APPLICATION NO.	FILING DATE	FIRST NAMED INVENTOR	ATTORNEY DOCKET NO.	CONFIRMATION NO.
10/797,376	03/10/2004	Christoph Richter	2002P15599US	4466

Office Action Summary

DETAILED ACTION

Figures 1-6 of Allen

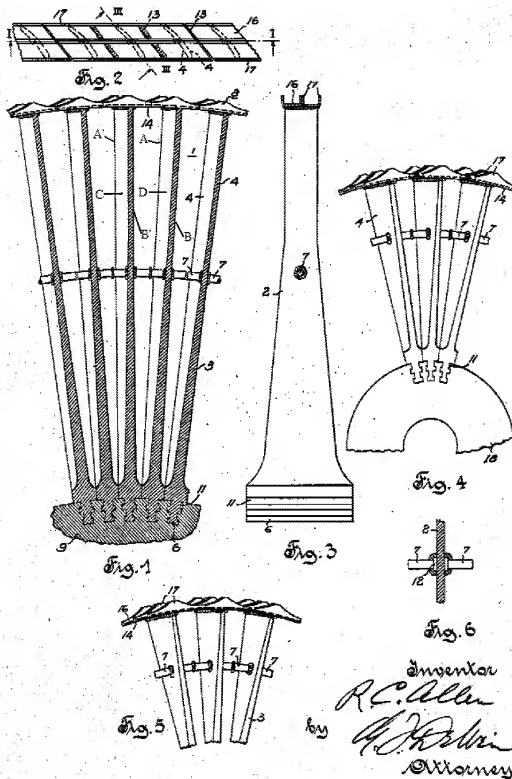
2. Claims 1, 3, 5-11, 13, 15, 16 and 18 are rejected under 35 U.S.C. 102(b) as being anticipated by US Patent Number 2,278,040 (Allen hereinafter).

3. In re claim 1, Allen discloses:

a blade (2) having a root (6), a center region, a tip, a leading edge and a trailing edge, the blades arranged circumferentially adjacent to each other to form a row; a shroud plate (8) arranged at each blade tip, the shroud plate (8) adapted to inhibit untwisting of the blades (2); and

a support element (7) arranged between adjacent blades (2) located approximately in the blade center region and coupling the adjacent blades (2).

a first rotating blade (C) with a first leading edge (A'), a first trailing edge (B'), a first blade tip, a first blade root, a first blade center region, and a first blade shroud located near the first blade tip;

a second rotating blade (D) with a second leading edge (A), a second trailing edge (B), a second blade tip, a second blade root, a second blade center region, and a second blade shroud located near the second blade tip; and
a support element (7) located between the first rotating blade (C) and the second rotating blade (D) and arranged approximately in the blade center region, and adapted to couple the first rotating blade (C) to the second rotating blade (D).

The rotating blade as claimed in claim 6, wherein a plurality of first rotating blades (C) and second rotating blades (D) are arranged on a rotor (9) of the turbo-machine to form a row of rotating turbine blades.

The rotating blade as claimed in claim 6, wherein the first rotating blade shroud has a contact face (13) and the second rotating blade shroud has a contact face (13).

The rotating blade as claimed in claim 10, wherein blade untwist is prevented by the first rotating blade shroud contact face (13) contacting the second rotating blade contact face (13) during operation.

*FIG. 5.***Figure 5 of Ortolano**

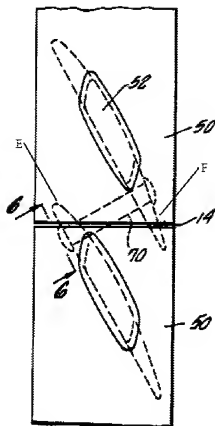
18. In re claim 2, Allen discloses all of the limitations except wherein the leading edge (E) of the blade is coupled to the trailing edge (F) of an adjacent blade by the supporting element (shown as 70 in Figure 5). However, Ortolano teaches this as seen in Figure 5 above.

19. It would have been obvious to one having ordinary skill in the art at the time the invention was made to combine the location of the supporting element taught in

Ortolano with the blade row disclosed by Allen for variations where the blade centers did not line up for convenient connection via the supporting element.

20. In re claim 12, Allen discloses all of the limitations except wherein the leading edge (E) of the first rotating blade is coupled to the trailing edge (F) of the second rotating blade by the supporting element (shown as 70 in Figure 5). However, Ortolano teaches this as seen in Figure 5 above.

21. It would have been obvious to one having ordinary skill in the art at the time the invention was made to combine the location of the supporting element taught in Ortolano with the rotating blade disclosed by Allen for variations where the blade centers did not line up for convenient connection via the supporting element.
